Volare Carburetors, LLC

Service Bulletin: SB-14 Rev A

SUBJECT – PART 178-47 (FLOAT BRACKET) FOR MSA UPDRAFT MODEL CARBURETORS.

FIGURE 1

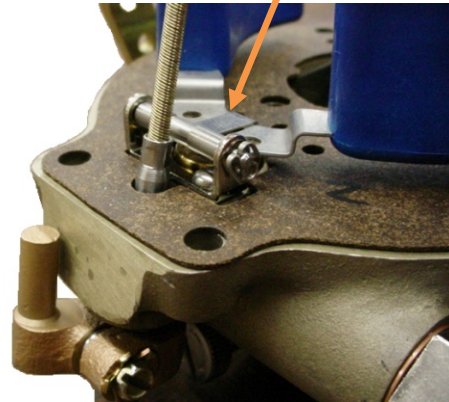
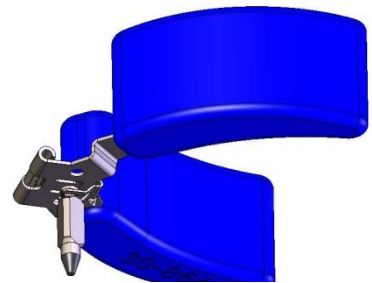
2. **Reason:** To advise the industry that bracket 178-47 is no longer used and has been removed from production float assemblies 30-862 and 30-864 as of 2010.

3. **Background:** Before 2005, float assemblies utilized a wire clip 29-194 to secure the float needle to the float assembly. After that time, a stamped clip 29-184 (See Illustration) was used, rendering the 178-47 see figure 1 float bracket superfluous.

4. **Compliance:** **None** – Note: Existing stock float assemblies with brackets may be used until exhausted.
5. **Voiding of Warranty and Waiver of Liability:** Operation of a carburetor in which other than genuine Volare approved parts are installed **voids any otherwise applicable warranty and constitutes a complete and total waiver** to the extent permitted by law of any and all rights the owner, operator and/or service facility or repairer may have had to hold Volare responsible or liable for the malfunction or failure of such an aviation carburetor. The owner/operator and/or service facility or repairer that makes an unauthorized repair or modification to a Volare carburetor shall bear the sole responsibility and full liability for any **damages of whatever nature, injury, or death** arising from any malfunction or failure of such a non-compliant aviation carburetor.
